ARKANSAS NUCLEAR ONE - UNIT 1

IMPROVED TECHNICAL SPECIFICATIONS SUBMITTAL

VOLUME 2 OF 7

January 28, 2000

Figure No. 3.5.4-1

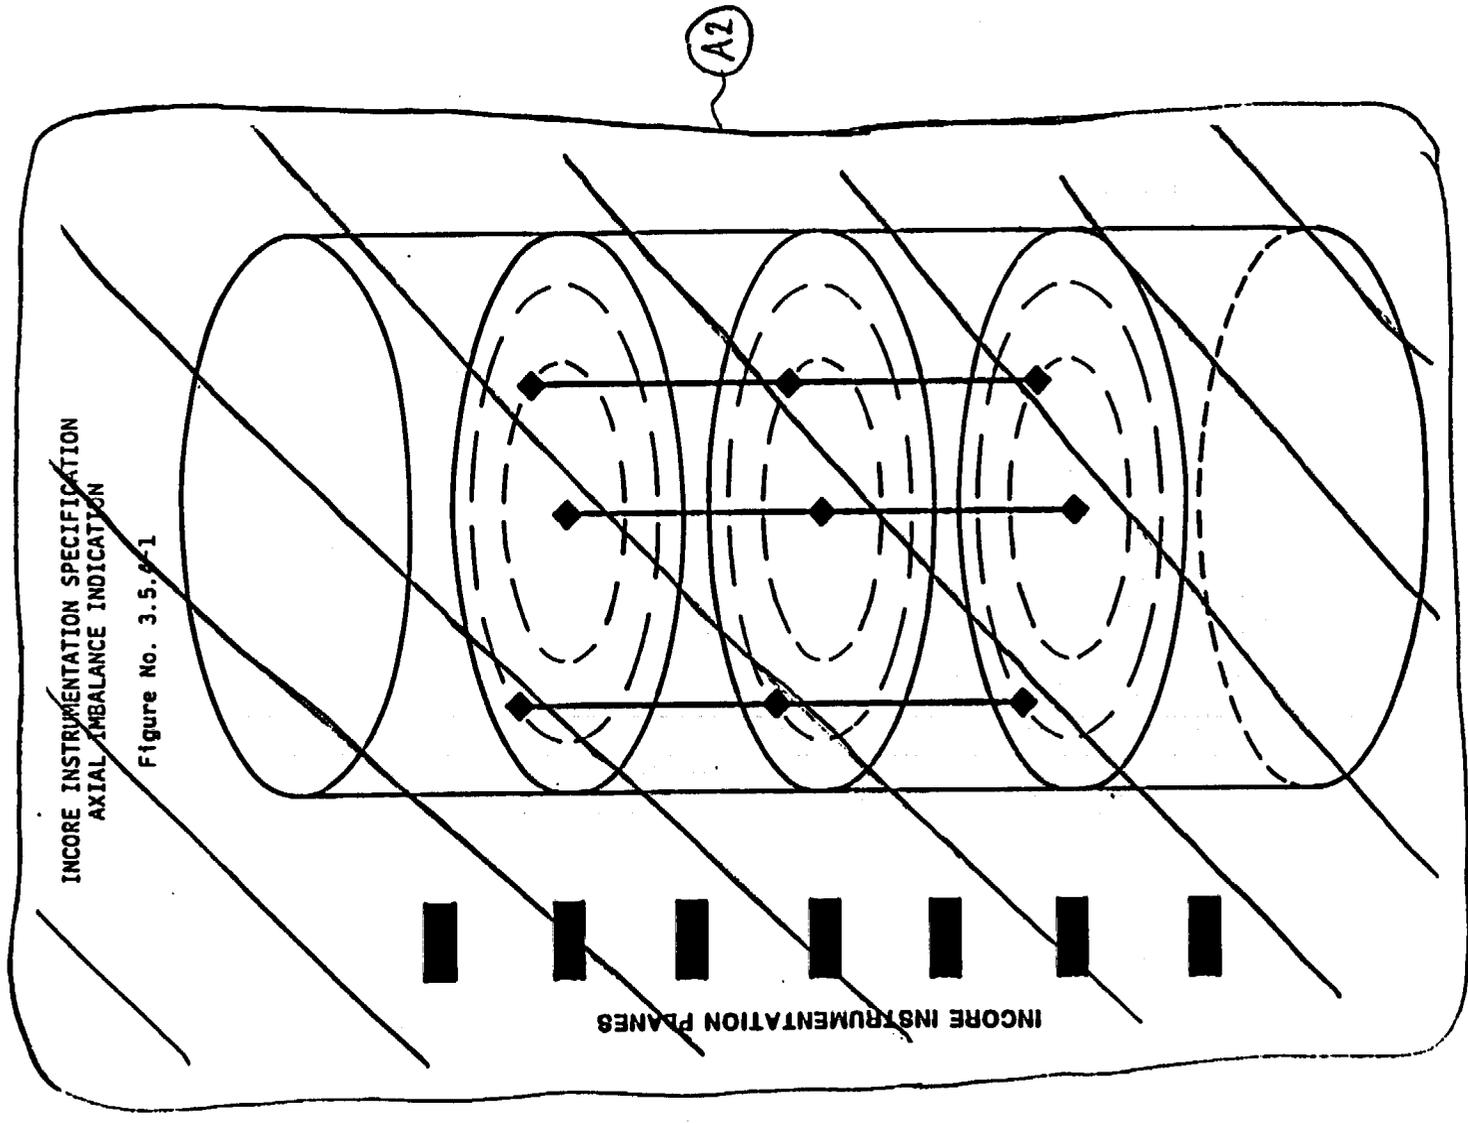
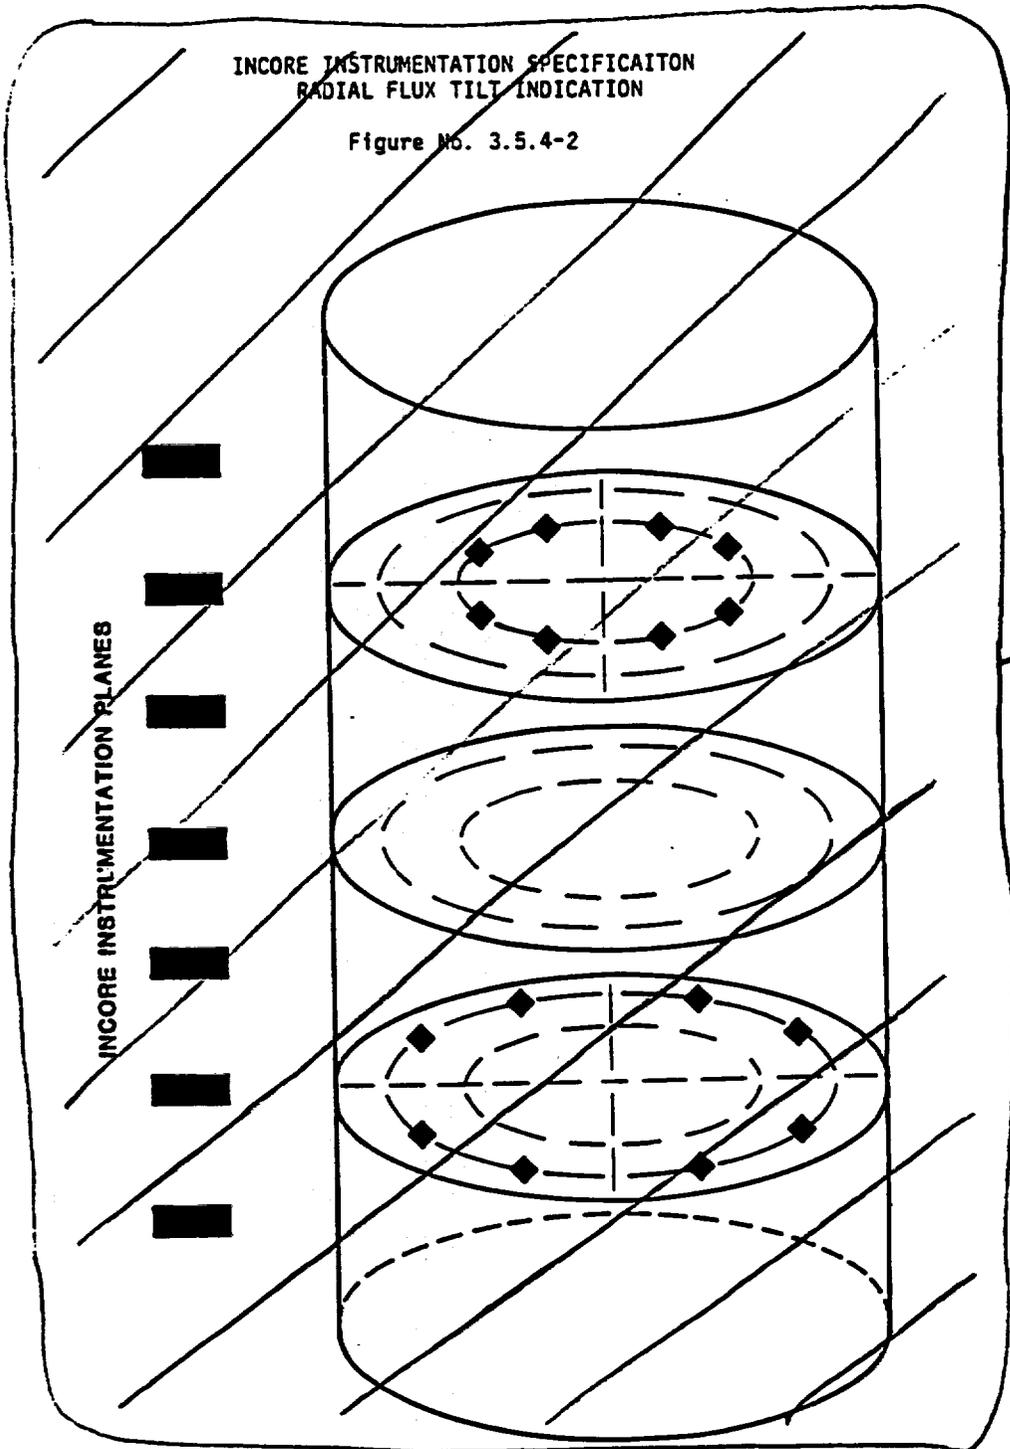
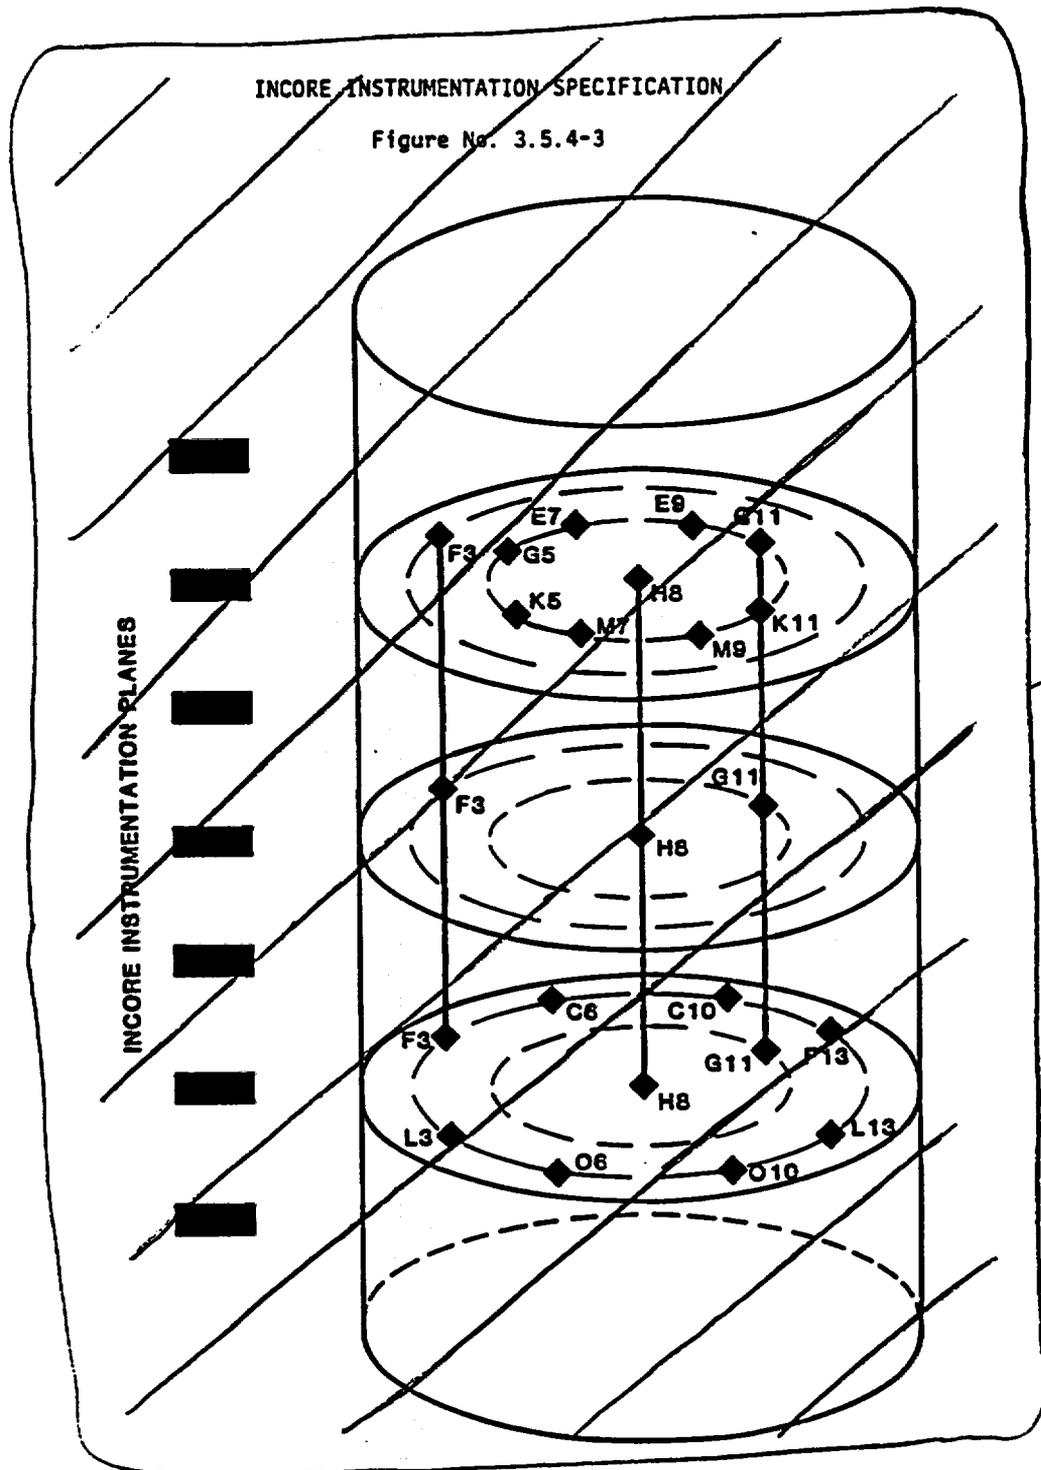
- D. The minimum requirement for 23 individual incore detectors is based on the following:
1. An adequate axial imbalance indication can be obtained with 9 individual detectors. Figure 3.5.4-1 shows a typical set of three detector strings with 3 detectors per string that will indicate an axial imbalance. The three detector strings are the center one, one from the inner ring of symmetrical strings and one from the outer ring of symmetrical strings.

2. Figure 3.5.4-2 shows a typical detection scheme which will indicate the radial power distribution with 16 individual detectors. The readings from 2 detectors in a radial quadrant at either plane can be compared with readings from the other quadrants to measure a radial flux tilt.

3. Figure 3.5.4-3 combines Figures 3.5.4-1 and 3.5.4-2 to illustrate a typical set of 23 individual detectors that can be specified as a minimum for axial imbalance determination and radial tilt indication, as well as for the determination of gross core power distributions. Startup testing will verify the adequacy of this set of detectors for the above functions.

Figure B 3.2.3-1 (page 1 of 1)
Minimum Incore System for AXIAL POWER IMBALANCE Measurement

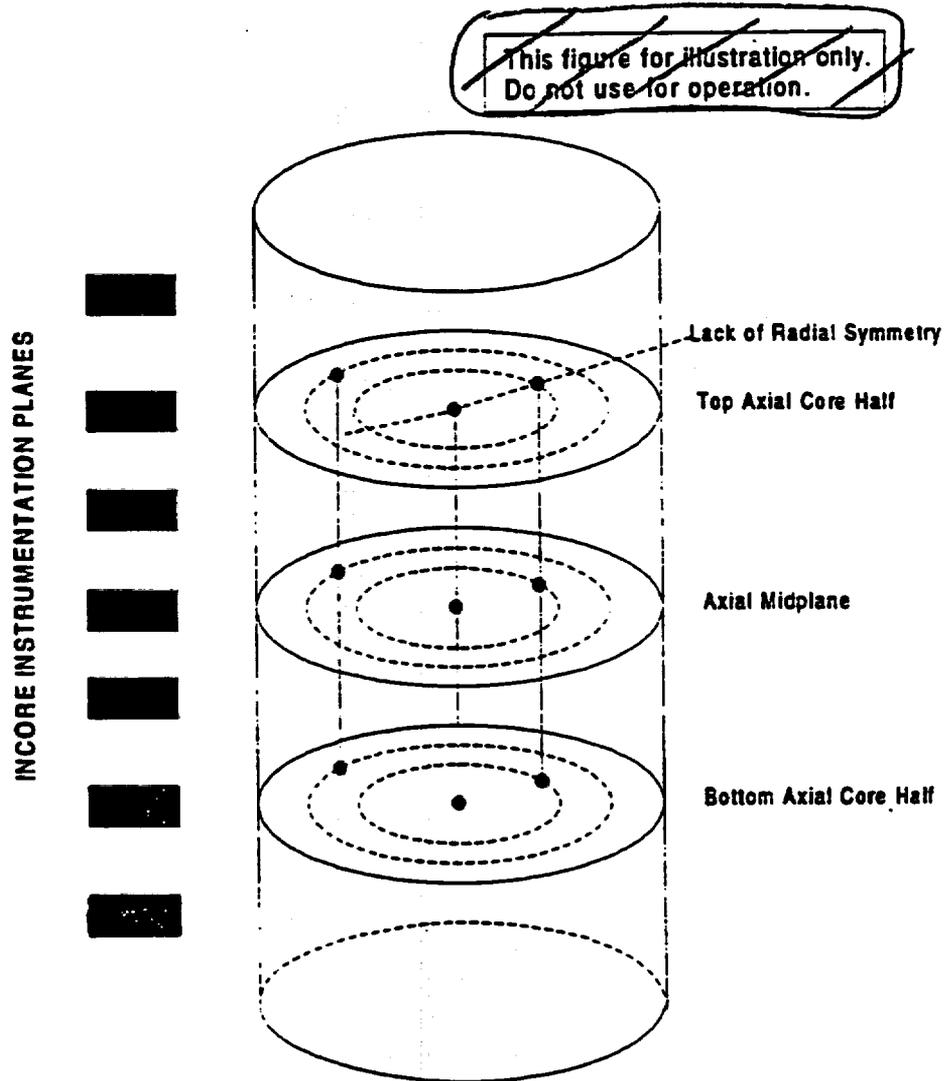
~~This figure for illustration only.
Do not use for operation.~~

edit
